04 Balcony design / daylight sunlight

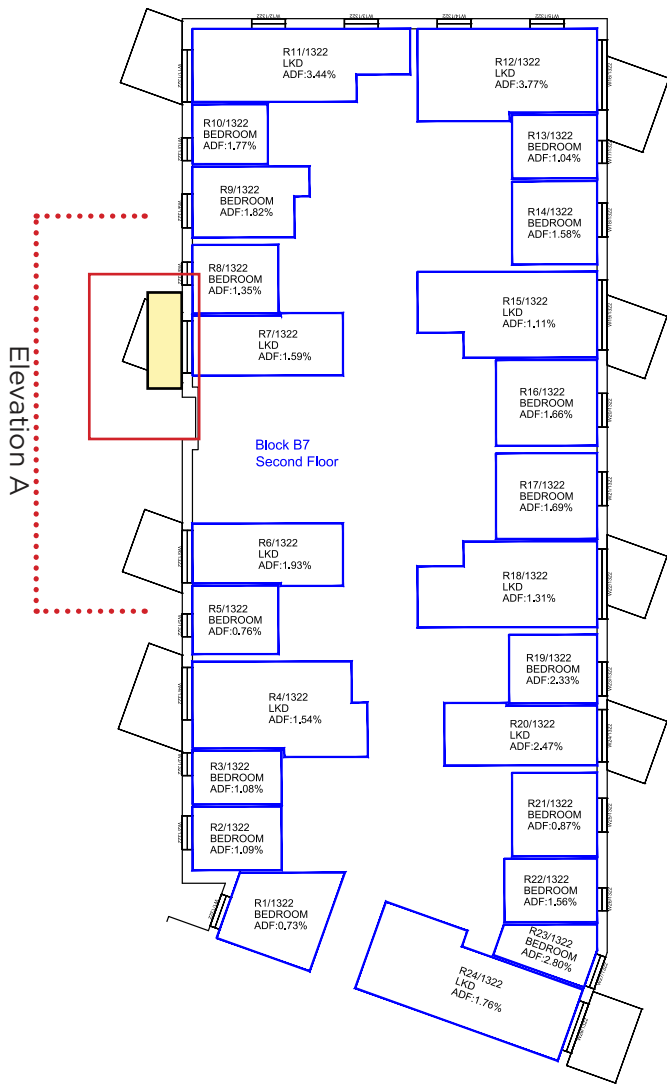
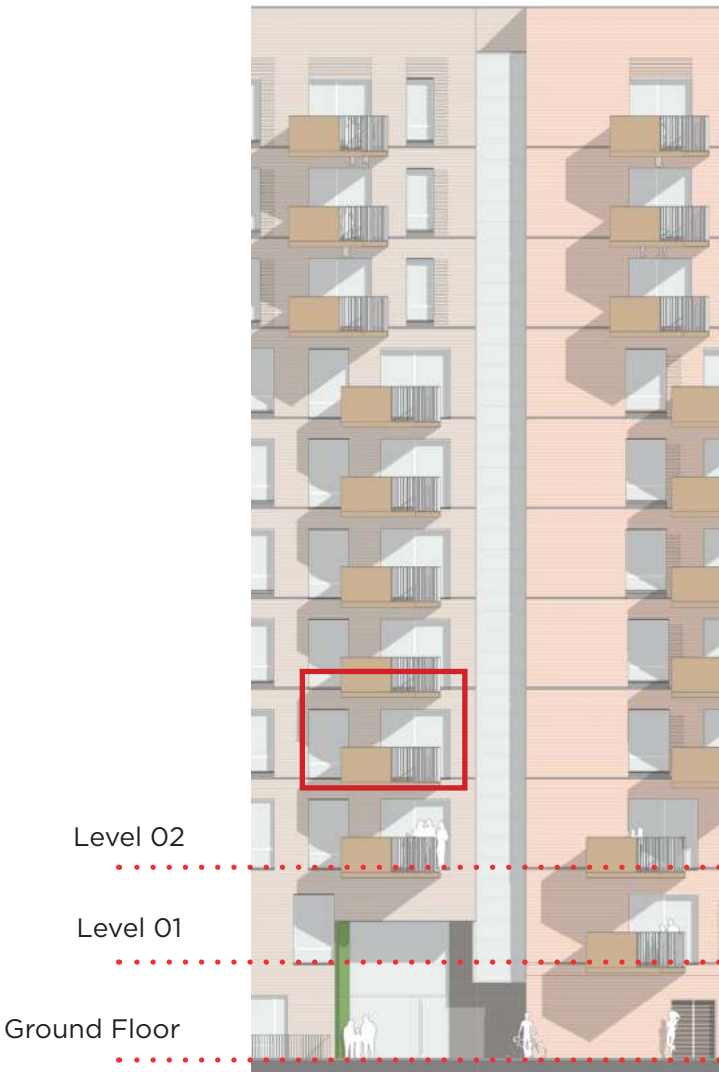
The proposed amendments to the balconies reduce the projection from the building façade and therefore the overshadowing from the balconies.
